(This Service Bulletin is FAA D.O. Authorization SW-1 Approved)

SUBJECT: INSTALLATION OF OPERATION PLACARD - P/N 150010-111

MODELS AFFECTED: M20 and M22 Series Aircraft

SKETCH 1 (M-20 SERIES FLIGHT PANEL)

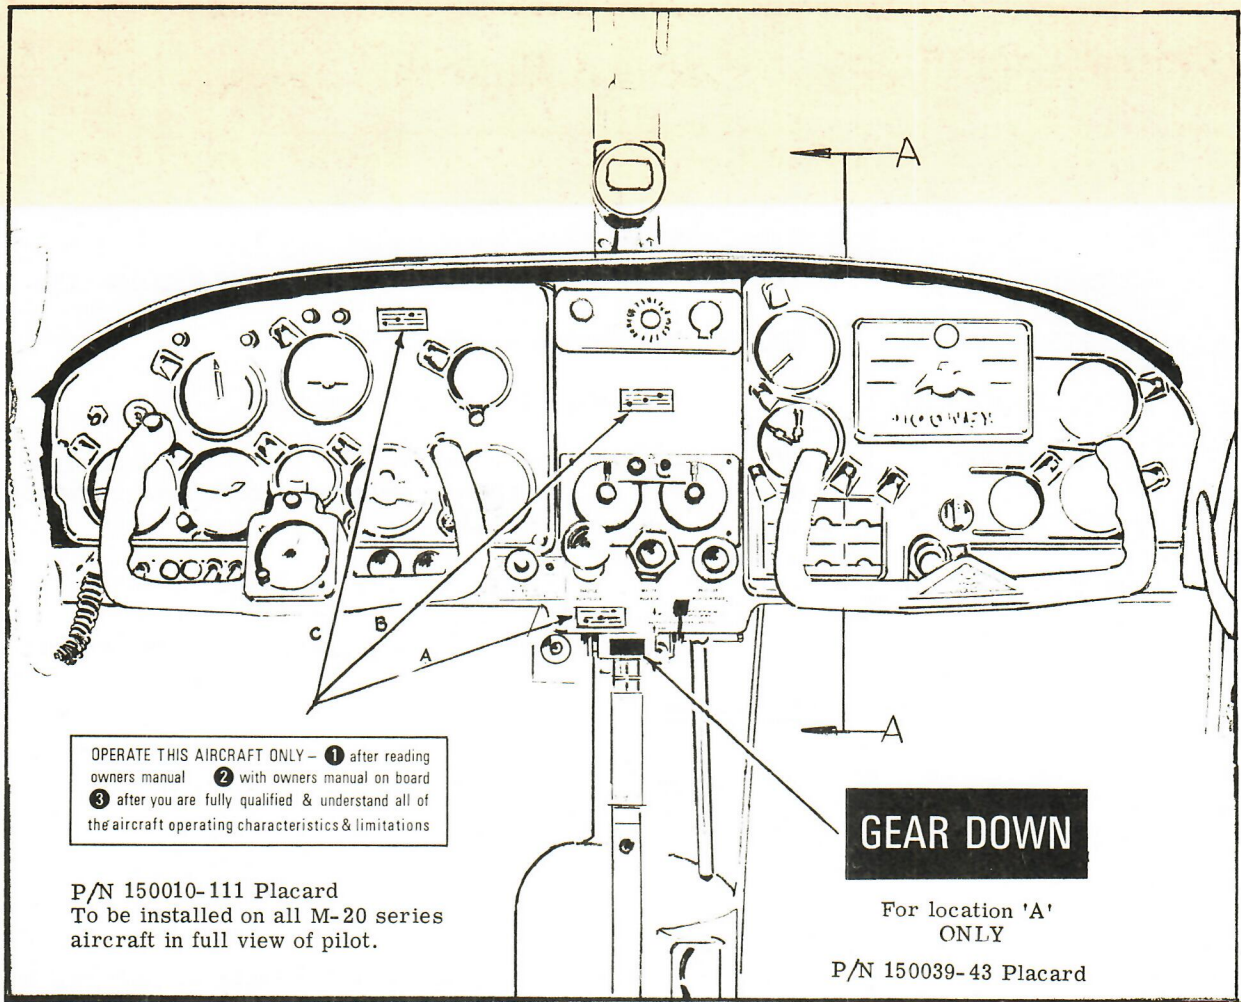
- (1) Location A (Shown on Sketch 1) - order Kit No. 1
This is the location for adhering placard 150010-111 on aircraft:
M20C S/N's 2321 thru 670134
M20D S/N's 1, 101 thru 260
M20E S/N's 101 to 680001
M20F S/N's 660002 thru 670485
Placard P/N 150039-43 (Gear Down) is to be adhered as shown on Sketch 1 if placard 150010-111 is adhered per this recommended 'A' location.
- (2) Locations B, C (Shown on Sketch 1)
Locations B and C (optional) are for other M20 aircraft not feasible on location A.
- (3) If this placard cannot be installed on recommended locations A, B, or C, then it is to be adhered to the left of line A-A (shown on Sketch 1) on the flight panel--in full view of pilot.
- (4) Adhere sticker* to outside of front cover of M20 Series Aircraft Owners Manual.

SKETCH 2 (M-22 SERIES FLIGHT PANEL)

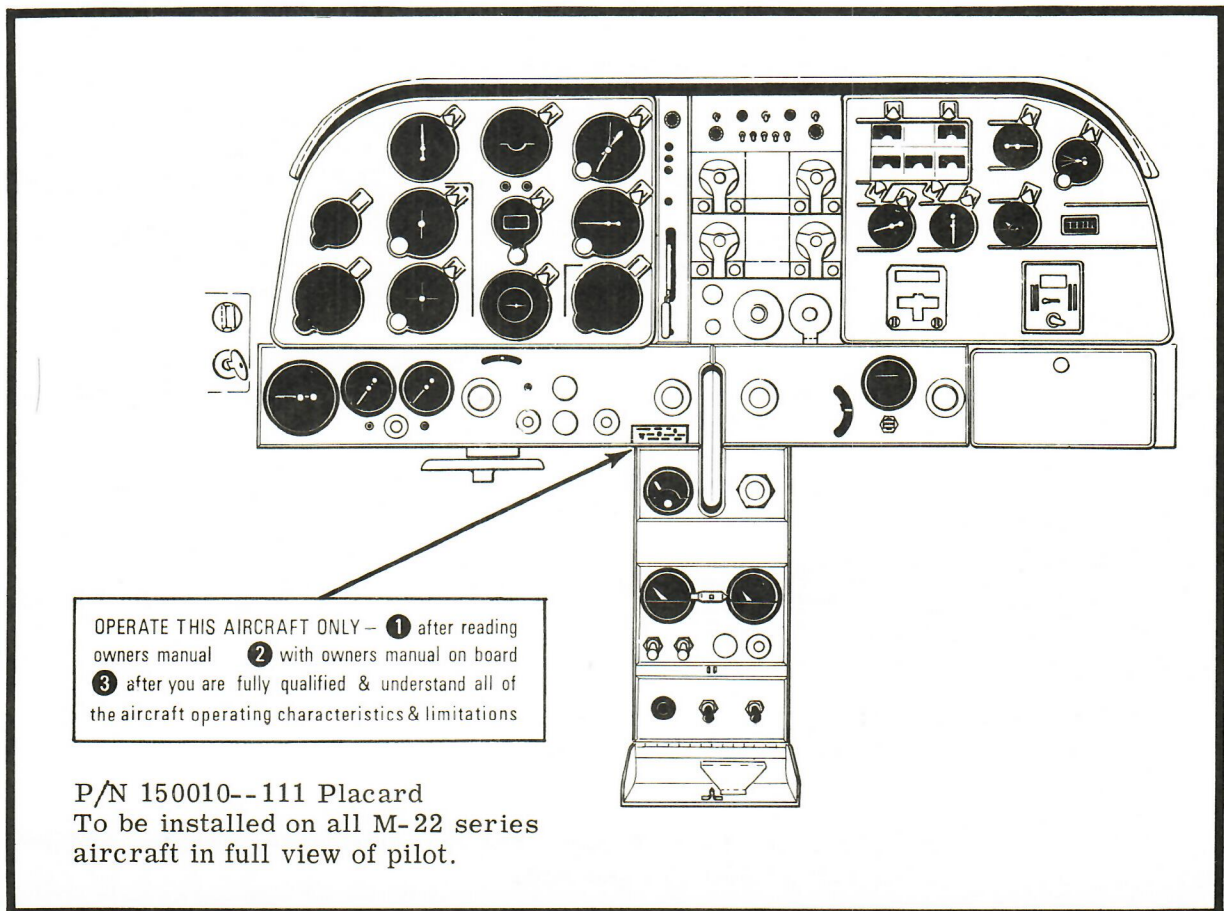
- (1) Adhere P/N 150010-111 placard on M22 S/N's 670001 and 670002 as shown on Sketch 2.
- (2) Adhere sticker* to outside of front cover of M22 Series Aircraft Owners Manual.
